RESOLUTION 2013-54

A RESOLUTION APPROVING A DEVELOPMENT PLAN FOR THE COTTAGES ON CUMMINS STREET PUD SUBDIVISION, LOCATED AT 411 CUMMINS STREET, BY THE CITY OF FRANKLIN, TENNESSEE.

FRANKLIN MUNICIPAL PLANNING COMMISSION REPORT

NAME OF PROJECT: The Cottages on Cummins Street PUD Subdivision,
development plan, revision 1

C3.0
PROJECT: 2010-06
DATE: 06/15/2010

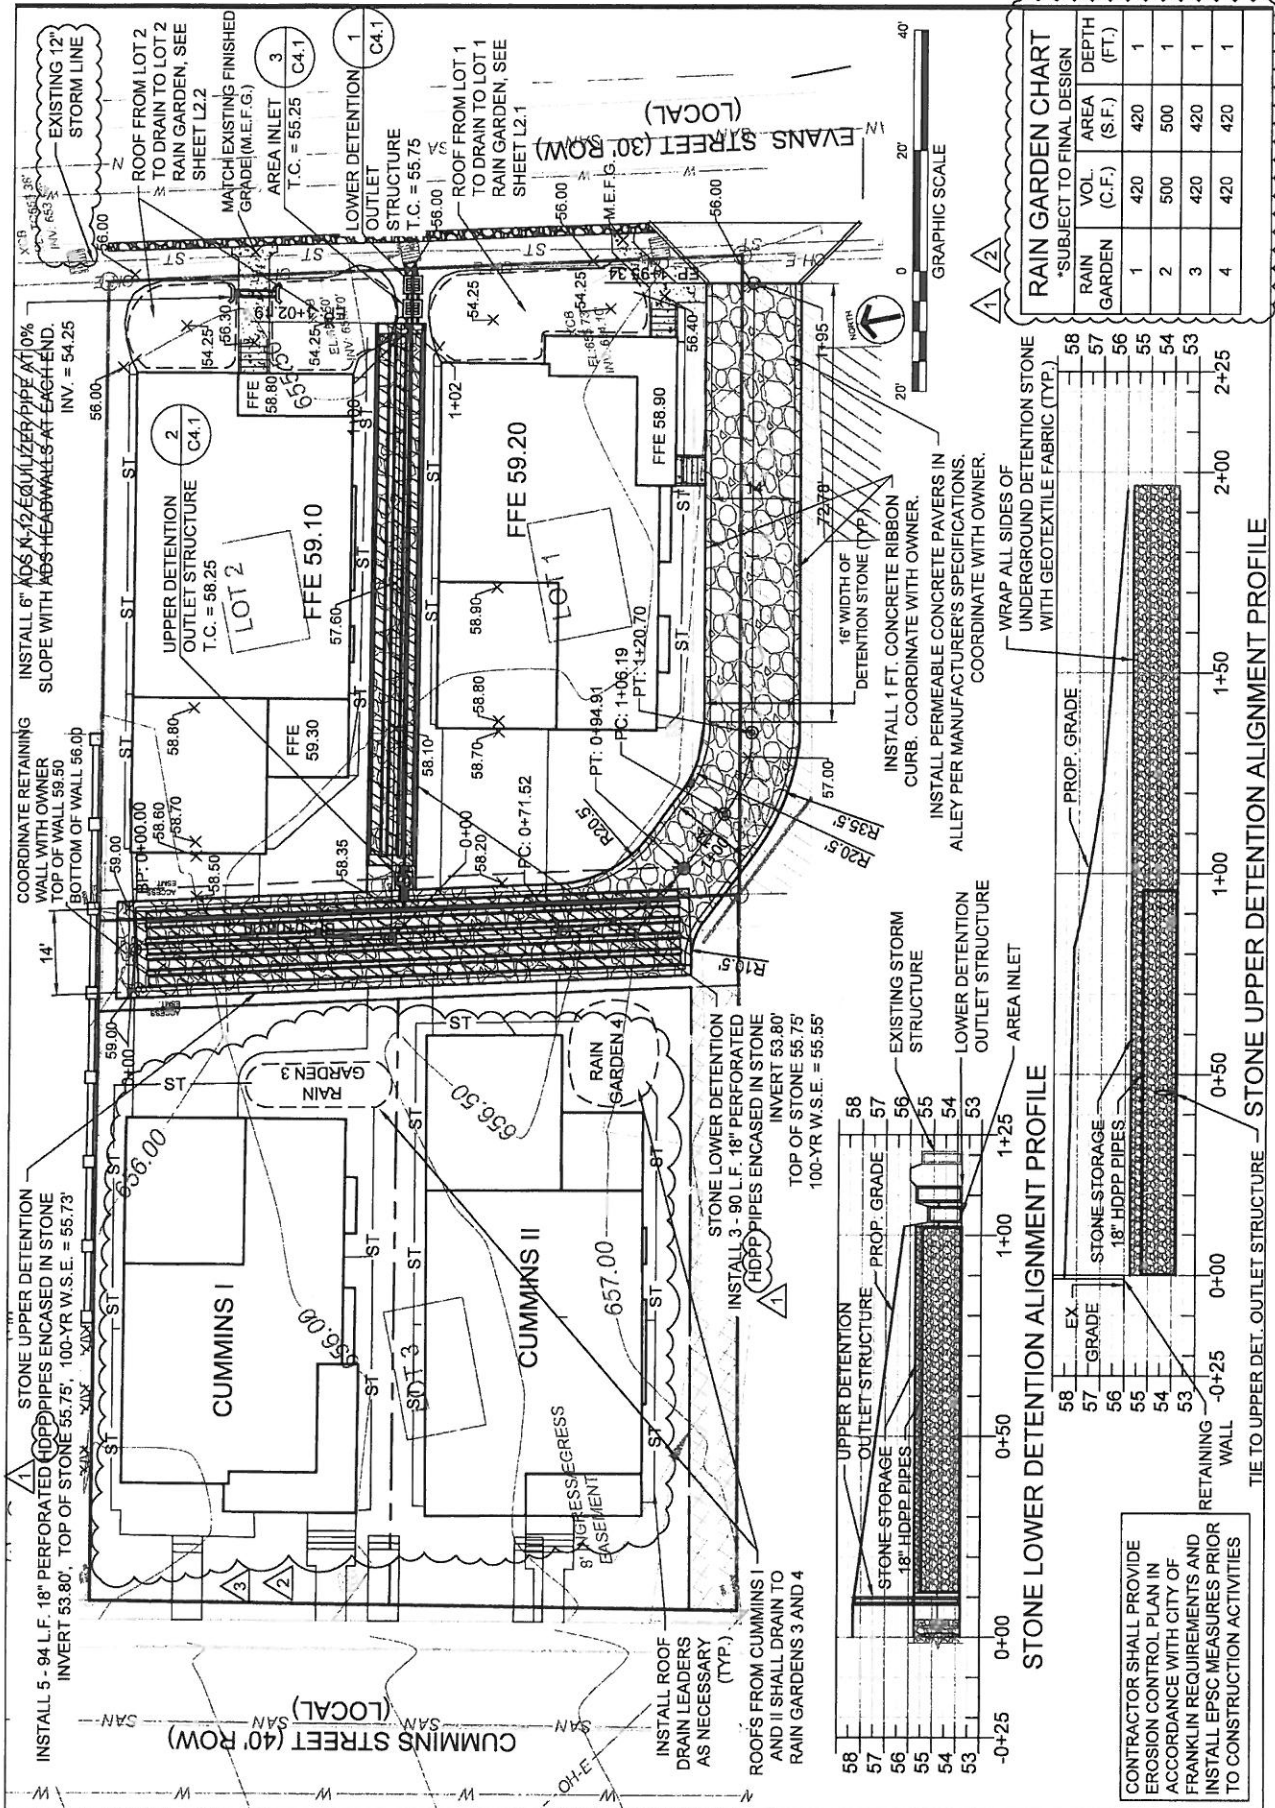
- ~~The steps and porches on sheet C3.0 indicate these housing units will be duplexes. Provide the proper amount of parking for duplex units.~~

- Provide fencing around the raingardens to prevent vehicles from parking or driving over the raingardens.

2 UPPER DETENTION OUTLET STRUCTURE

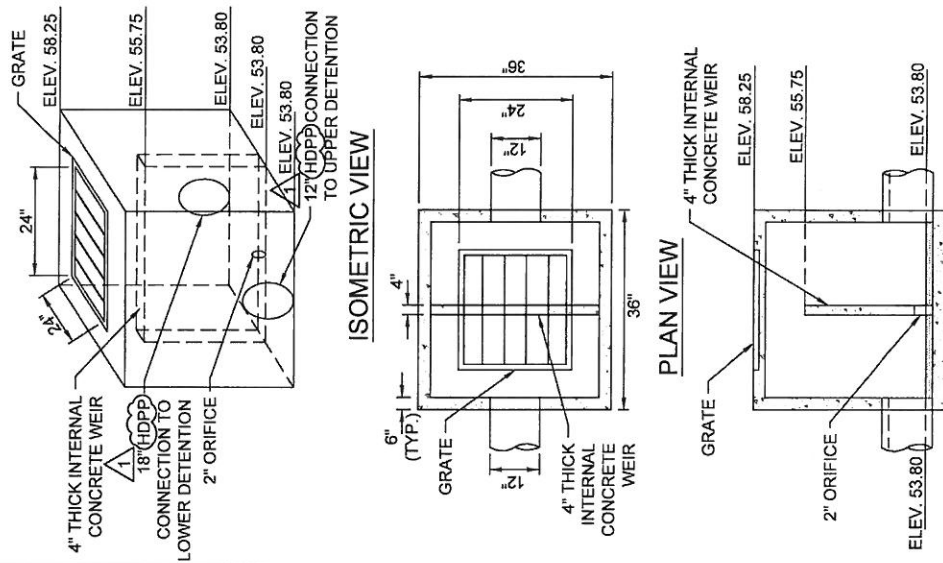
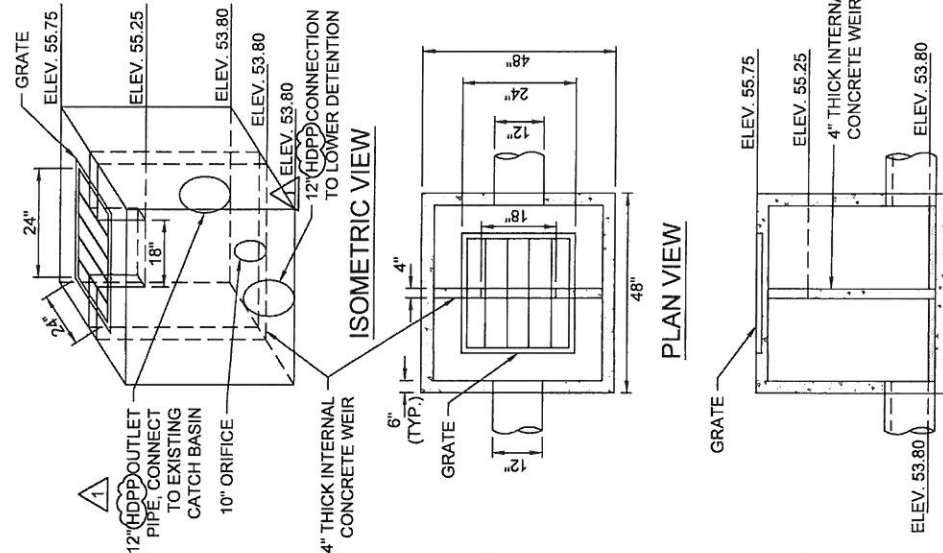
- Provide the proper stone bedding under the detention structures.
